## APPENDIX 7

### CPTED STATEMENT

## FRANK KITTS PARK LANDSCAPE REDEVELOPMENT: CPTED STATEMENT

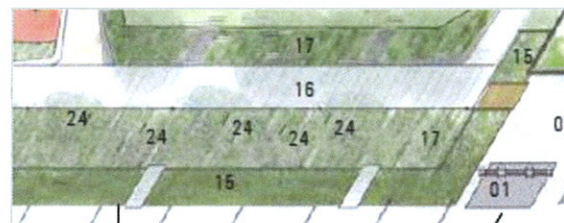
- 3.16. Memorial plaques [24] will be relocated to the edge between the coastal garden [17] and the park promenade [16]. In this location they are more open to view and less susceptible to theft and vandalism than in their former location along the sea wall.
- 3.17. Note that bronze plaques are highly vulnerable to theft for scrap metal and should be fixed very securely to their mounts - wherever and however they will finally be displayed.

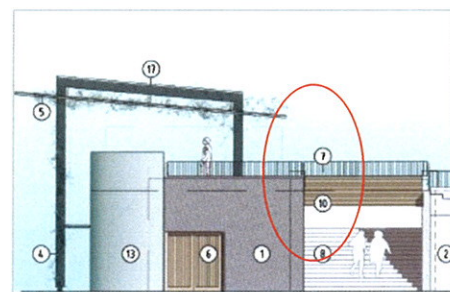
- 3.18. The City Lawn is more likely to be activated than the present location is at present given the new grand steps to the lagoon, the stronger city-side link and in particular the Pavilion/canopy. These are seen as highly positive CPTED elements. The Terrace Steps are sufficiently wide to so as to feel safe to use even if people are sitting on them.
- 3.19. The existing steps [8] between the promenade and the upper lawn in the southeast corner feel risky and unpleasant to use - particularly at night. This mainly because it is difficult to see ahead from either side. Moreover the stair enclosure is confining, the stairs and surrounding surfaces are poorly lit, and the surfaces are dark and tough. The bulky handrail which no longer meets code will be replaced.

It is understood the handrails [7] will be upgraded. The steps will be lit better at night ideally with wall washing light, possibly from the new bridge [10] above. The steps are an important element of an important corner of the park that is being strengthened by the proposed Te Tirohanga and the Pavilion.

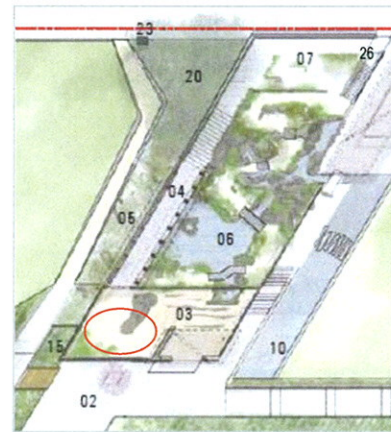
- a The hidden space [circled] behind the two metre high wall at the entrance [03] off the city side pedestrian link [02]. This has the potential as an entrapment space and risks being soiled;

- c The chambers [06], [07], which of necessity need to be secluded and isolated from the external environment in the park. These human-scale 'outdoor rooms' are a potential congregation point for antisocial purposes, as has been experienced in similar contexts, elsewhere on the waterfront and in the region. Antisocial behaviours include general disorderly conduct, prostitution, drinking, drug dealing and soiling. The chambers also risk being damaged through unintentional use, and being abused deliberately in various disrespectful ways;

- e The gardens are also directly accessed from the Pavilion and the upper terrace;
- f In addition to the main entrance off the city link pedestrian pathway [02], there is also a secondary entrance in the southwest corner of the garden

[26]. This provides access to and from the harbour promenade. The CPTED issue with this, is that it is impossible to determine whether the pathways within the gardens and its associated entrances are primarily being used for the purposes of enjoying the gardens - or whether the gardens are merely being used as a short cut. Such examples of a lack of 'clarity of purpose' make spaces of this nature vulnerable to crime and abuse under pretext of ambiguous uses.

- g The eastern entrance and stairway to the gardens has the same potential to feel and be risky as the above-mentioned existing staircase in the southeast corner of the park. Again, it is recommended that this entrance too, be subjected to careful detailed design consideration.

- a the Chinese Garden area will be locked at night. This proposal is very much endorsed. There is no reason why the gardens need to be visited late at night or used as a shortcut given other reasonable alternatives. There are precedents for securing vulnerable city amenities after hours;

- b there are gates at both entries for locking off the gardens at night;
- c at the promenade end, the gates will be flush with the eastern wall so as to eliminate an unwanted, potentially risky recess.

- d to allow the line between the Pavilion and the gardens to be secured after hours, there will be combination of fixed transparent screens, sliding panel gates at the eastern end - and a barrier formed by the water feature, edged with rocks, at the western end.

- e in consultation with the Council, a lighting strategy has been developed whereby it is proposed that there will be low level / feature lighting for the Chinese garden until 11 o'clock; with motion sensor activated lighting thereafter;

- f the Council are also considering the possibility of CCTV coverage on nearby light columns for the entries to the Chinese Gardens and the park entry and exit point near the playground. This will be considered further in collaboration with the Council during detailed design.

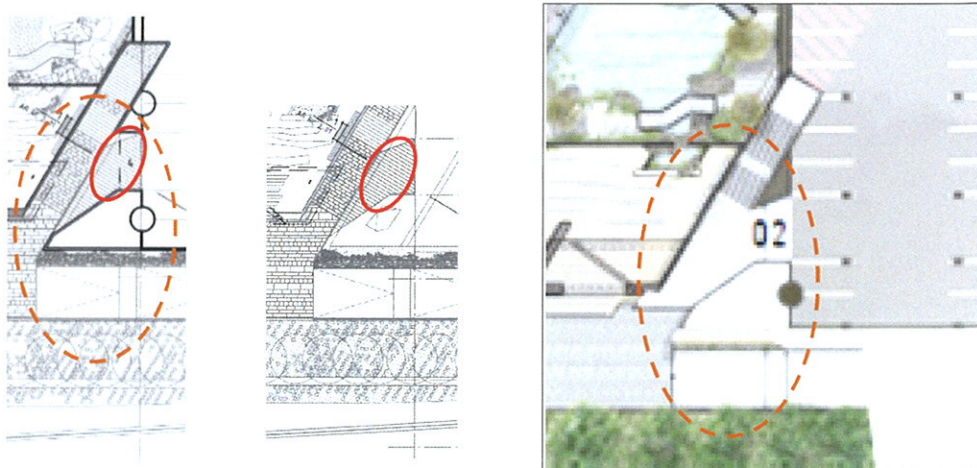
- 3.24. Aside from changes to the northern entrance there are no changes proposed for the existing car park under the city lawn.
- 3.25. There is a small space where the stairs to the upper terrace, and the northern pedestrian and vehicular entrances [02] into the car park converge behind the south wall of the Chinese Garden's entry courtyard. The area around the proposed revised entrance is potentially problematic for pedestrian safety and preserving good standards of amenity. It could well be used for gathering, drinking and soiling as similar informal outdoor rooms on the Waterfront have suffered in the past.

While the approach to the stairs and the pedestrian entrance to the car park are partly viewable from the Quay, there is a significant area which is hidden from view because of the western edge of the car park building.

- 3.26. Potential ways to mitigate the risk of misuse and mistreatment are through the use of high levels of lighting, quality materials, and conspicuous CCTV coverage - however these approaches are very much secondary and inferior to *building design* solutions. The preference would be to explore mitigations during detailed design. These could include consideration of ways of expanding the space near the pedestrian entrance to the car park, and attempting to open it up to view from the Quay - for example, by replacing the low wall with a column (if possible given the constraints of the existing building).
